HISTORIC PRESERVATION COMMISSION MEETING AGENDA

Wednesday, June 8, 2022, at 6:00 p.m.

H-13-22 (Quasi-Judicial Hearing)

Certificate of Appropriateness Request: H-13-22
Applicants: Tristan and Kristen Adamczuk
Location of Subject Property: 97 Union St N
PIN #: 5620-78-8882
Staff Report Prepared by: Brad Lagano, Senior Planner

Sheet:
G03

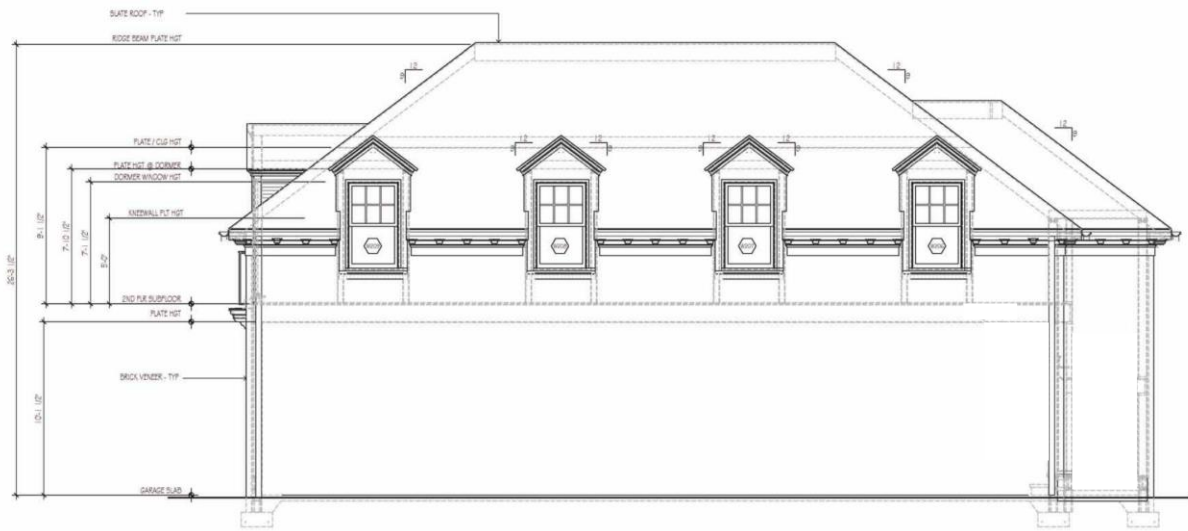
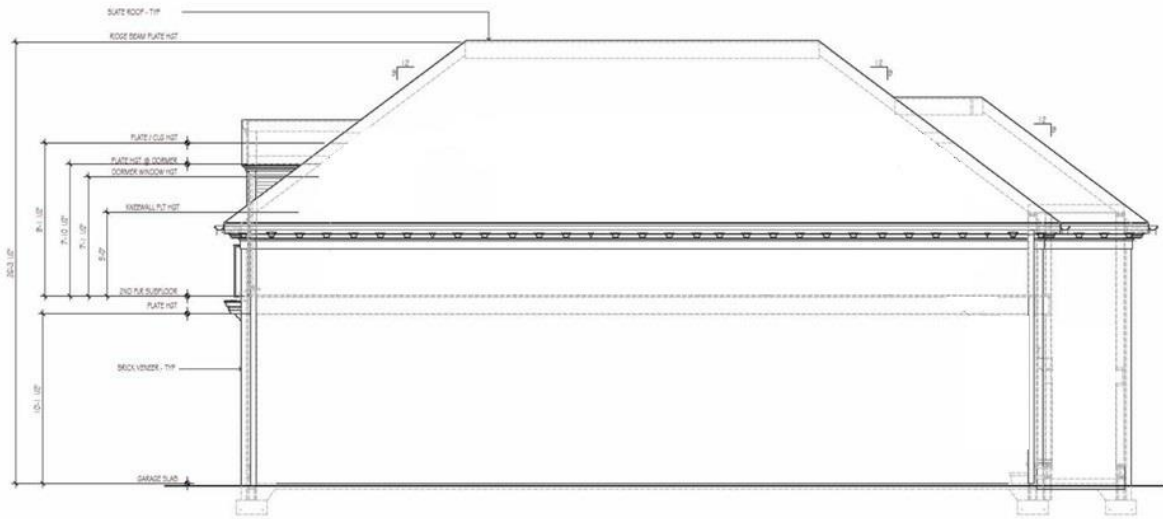
- The new garage was referenced in the recorded order as sheet GO3, Exhibit G, which showed the detached garage elevations to include four (4) dormer features on the rear side (Exhibits D, E).

- Completed construction of the new garage excluded four (4) dormers on the rear façade, contrary to the approved elevation. The building’s rear wall now includes a solid brick façade with no variations (Exhibits F, G).

- As can be seen on the approved elevations (Exhibit E), four (4) gable roof dormers were to be located on the second story, matching the four (4) dormers located on the opposite, garage door entrance, façade. Each dormer was designed with a single three-over-one window.
